Access Compliance Report Public Rights-of-Way (RR Crossings)

Intersection ID: 10032938	Main Street: NEW_BERN_ST	Location: N/A
ADA ID: D57887397594	Overall Compliance: No	Severity Score: 0.0
Codes/Mitigation Info/Possible Solution		Field Measurements/Component Compliance

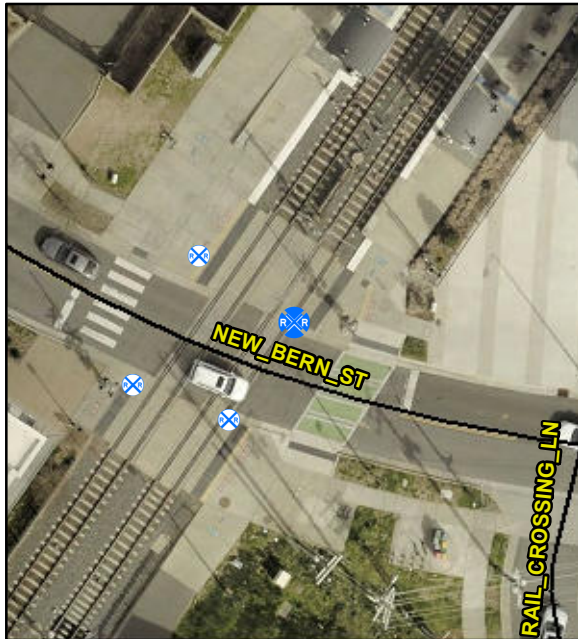
Remove & Replace Detectable Warning System. Provide Pedestrian Gate. Remove & Replace Walking Surface Adjacent to Rail.

Compliance	Description	Data
Yes	DWS Provided?	Yes
Yes	DWS Contrast?	Yes
Yes	DWS Width (in)	Yes
Yes	DWS Length (in)	36.0
No	DWS Offset (in)	28.5
No	Pedestrian Gate?	No
N/A	DWS Outside Gate?	N/A
N/A	Rail Type?	LightRail
No	Flangeway Gap (in)	3.0
Yes	Sidewalk Width (in)	63.0
